Access Compliance Report

Public Rights-of-Way

(Curb Ramps)

Intersection ID: 3794	Main Street: DEER_CROSS_TL	Cross Street: LAUREL_RIDGE_TL	Location: W
ADA ID: 4C2ADB805B8F	Ramp Type: Perp	Initial Pass/Fail: Pass	Overall Compliance: No
			Severity Score: 32.75

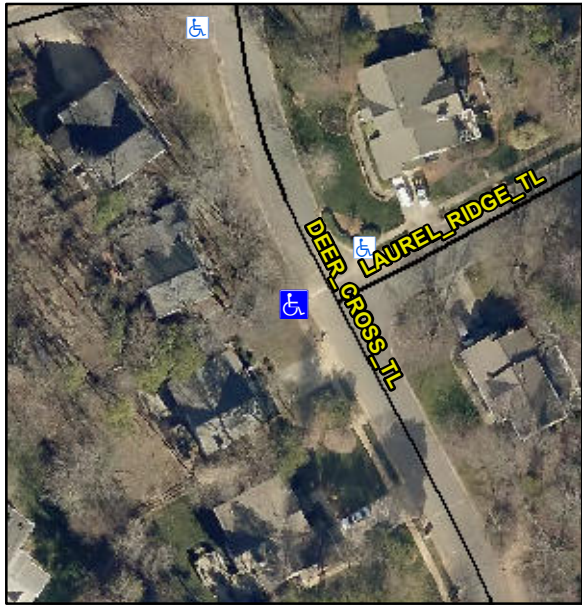
Codes/Mitigation Info/Possible Solution			Field Measurements/Component Compliance					
	Possible Solutions:		Compliance	Description	Data	Compliance	Description	Data
	Remove & Replace Entire Ramp.		N/A	Ramp Length (in)	49.0	Yes	Ramp Slope (%)	5.9
	Remove & Replace Gutter.		Yes	Ramp Width (in)	49.0	No	Ramp XSlope (%)	4.2
			N/A	Flare Type LT	Sloped	N/A	Flare Type RT	N/A
			N/A	Flare Slope LT (%)	10.5	Yes	Flare Slope RT (%)	3.0
			N/A	Flare Traversable LT?	Yes	N/A	Flare Traversable RT?	Yes
			No	Landing Length (in)	47.0	No	DWS Provided?	No
			Yes	Landing Width (in)	48.0	N/A	DWS Contrast?	No
			Yes	Landing Slope (%)	0.9	N/A	DWS Length (in)	N/A
			No	Landing X Slope (%)	4.0	N/A	DWS Full Width?	No
Surveyor Notes:	N/A		N/A	Landing Curb? (Y/N)	No	N/A	DWS Offset (in)	N/A
			N/A	Shared Landing?	No			
	PROW/ADA:		Yes	Gutter Ponding?	No	No	Gutter Slope (%)	6.1
	Not Found, R304.5.3, R304.2.1,		No	Gutter Lip Ht (in)	1.0	Yes	Gutter X Slope (%)	3.1

R304.2.3, R305, R302.7.2, R304.5.4		N/A	Painted X Walk1?	No	N/A	Painted X Walk2?	N/A
				X Walk 1 Direction	To E		X Walk 2 Direction	N/A
			N/A	X Walk 1 Width (in)	N/A	N/A	X Walk 2 Width (in)	N/A
				X Walk 1 Slope (%)	3.5		X Walk 2 Slope (%)	N/A
				X Walk 1 X Slope (%)	3.5		X Walk 2 X Slope (%)	N/A
			N/A	Ramp inside XWalk1?	N/A	N/A	Ramp inside XWalk2?	N/A
				Road Slope (%)	N/A	N/A	Clear Space?	Yes
				Road X Slope (%)	N/A	N/A	Clear Space to XWalk (in)	N/A
			Yes	Any Obstructions?	No	Yes	Storm Grate/Utility Hazard?	No
				Obstruction Type			Storm Grate/Utility Type	
					N/A			N/A
						Yes	Surface Condition? (G/P)	Good
Total Cost:		\$	2600.00
